**Appendix F:  
Hydrology and Water Quality Analysis**

**Memo**

To: Yael Marcus (FirstCarbon Solutions)  
From: Ed Ballman, P.E. CFM  
Date: May 7, 2021  
Subject: Draft Review of the Preliminary Stormwater Treatment Plan and Hydrology Summary for the Bishop Ranch 6 Project, City of San Ramon

Figure 1. Excerpt from FEMA Flood Insurance Rate Map 06013C0464F

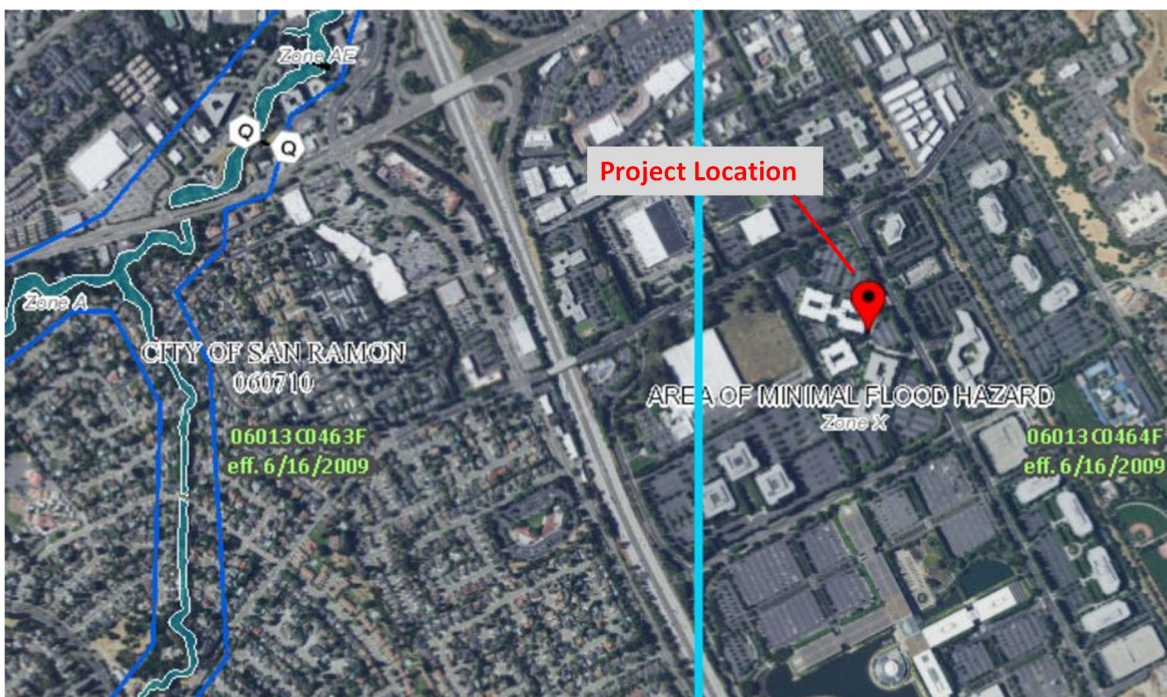
- *Floodplain Management Considerations.* Review of the FEMA Flood Insurance Rate Map covering the project area shows that the site is not located in a Special Flood Hazard Area, with the closest potential flooding source, San Ramon Creek, well to the west across the I-680 highway corridor and shown as contained in its channel as shown in Figure 1.
